Project: White Deer Run Reservoir
Project #: PW2017.010
Bid Number: #23002
Addendum #1
Date: March 24, 2023

Sheet Title: Single Line Electrical Riser Diagram
 Project Title: White Deer Run Reservoir
 Lake County Public Works

E1.0
 SHEET 1 OF 1

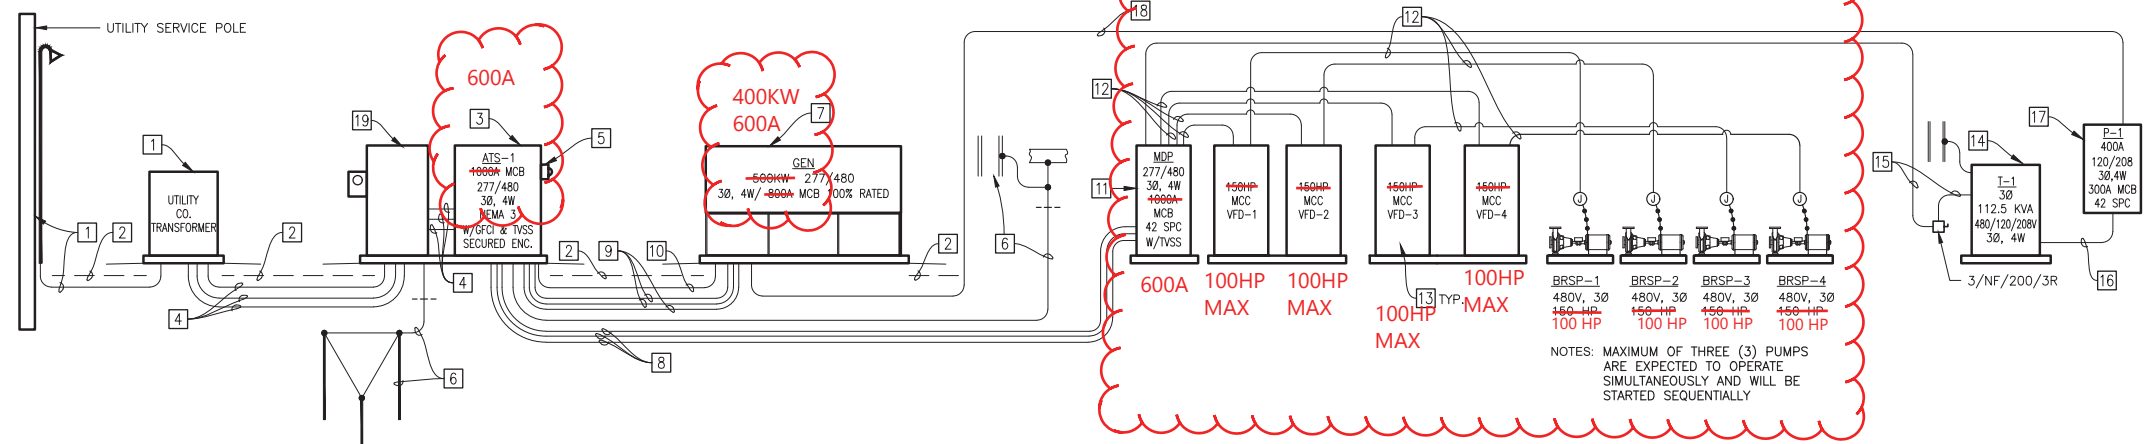
1. See revisions to Sheet E1.0 as attached to this Addendum.

Addendum No. 1 Edits

NOTES: MAXIMUM OF THREE (3) PUMPS ARE EXPECTED TO OPERATE SIMULTANEOUSLY AND WILL BE STARTED SEQUENTIALLY
